ADDENDUM # 3

Title: Flagg Road Extension - URI

NOTICE OF ADDENDUM NO. 3

State of Rhode Island
 Board of Governors for Higher Education
 University of Rhode Island
 Project No. KC.T.PVNG.2010.001
 Flagg Road Parking Lot
 Kingston, Rhode Island

DRAWING NUMBER
3
SHEET 3 OF 15

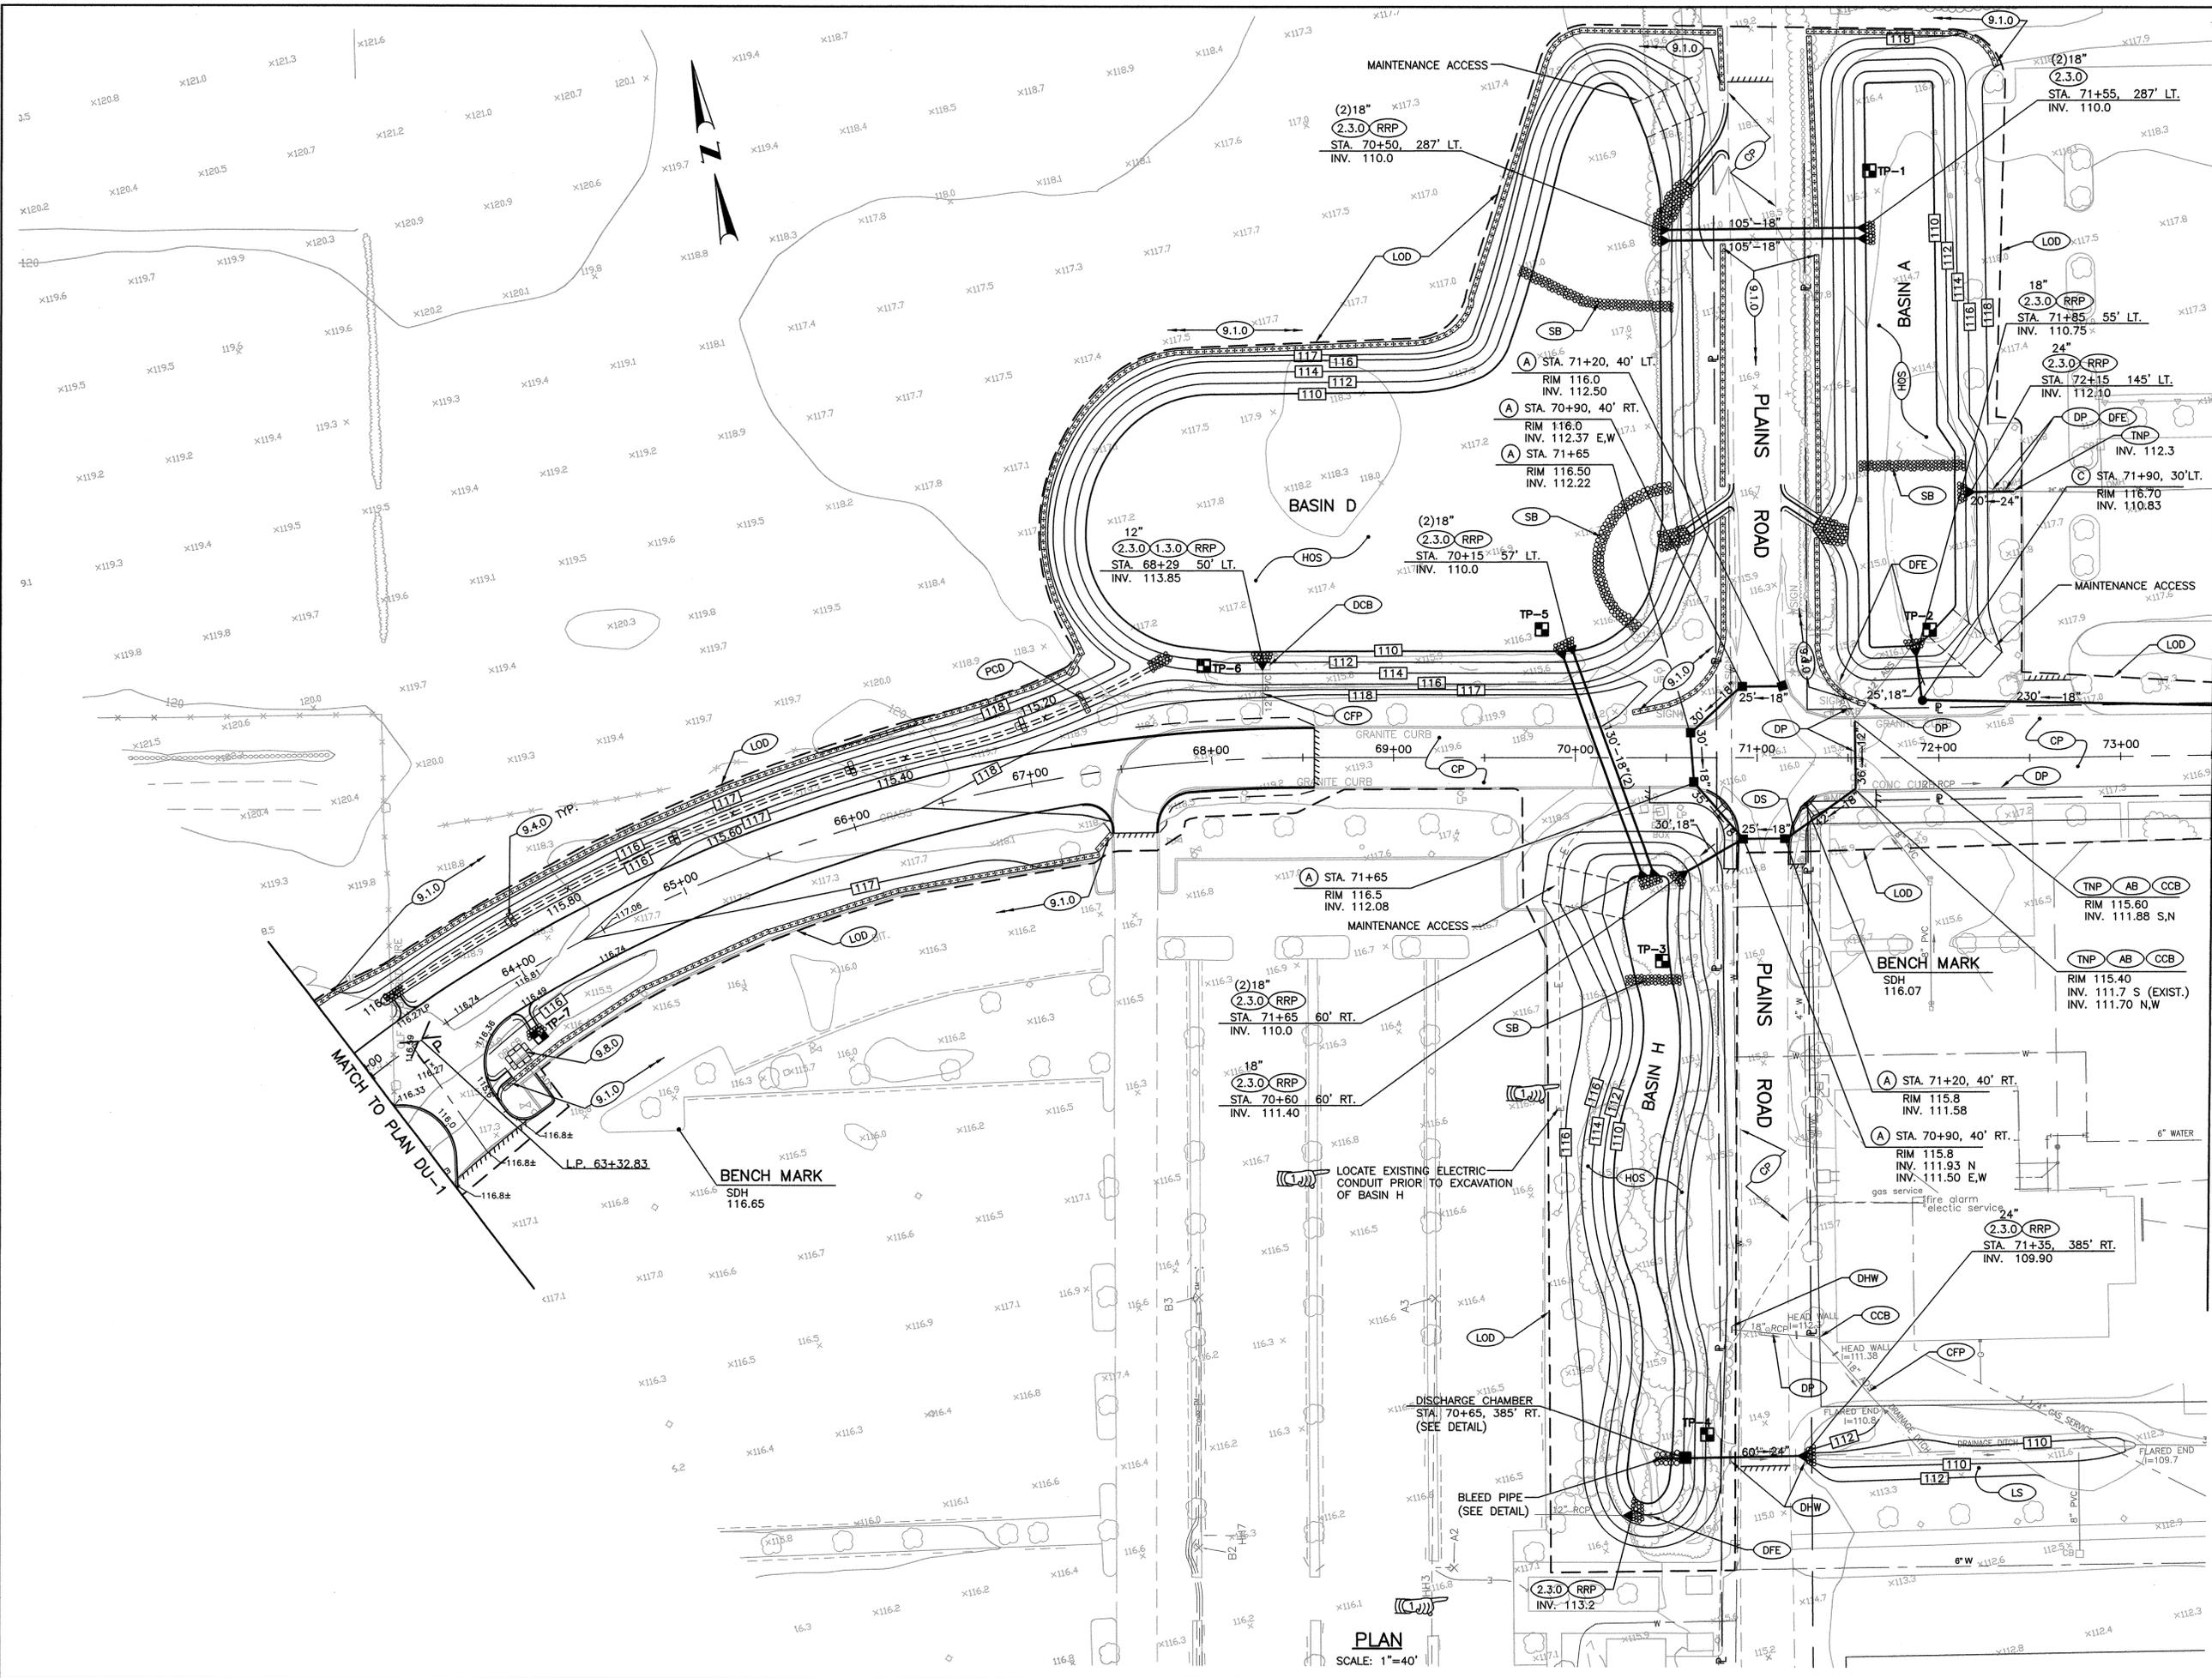
1. Delete the plans listed below and replace with the attached plan drawings for Addendum No. 3.

Dwg. No.	Drawing Title	Date
<u>Flagg Road Extension</u>		
3	Typical Sections	July 5, 2012
8	Grading & Drainage Plan 2	July 5, 2012
9	Grading & Drainage Plan 3	July 5, 2012
15	Detail 3	July 5, 2012
<u>Flagg Road Parking Lot (Alternate No. 2)</u>		
2	Legend and Notes	July 5, 2012
4	General Plan	July 5, 2012
9	Detail 3	July 5, 2012
13-15	Electrical Plan & Details (E-1 to E-3)	July 5, 2012
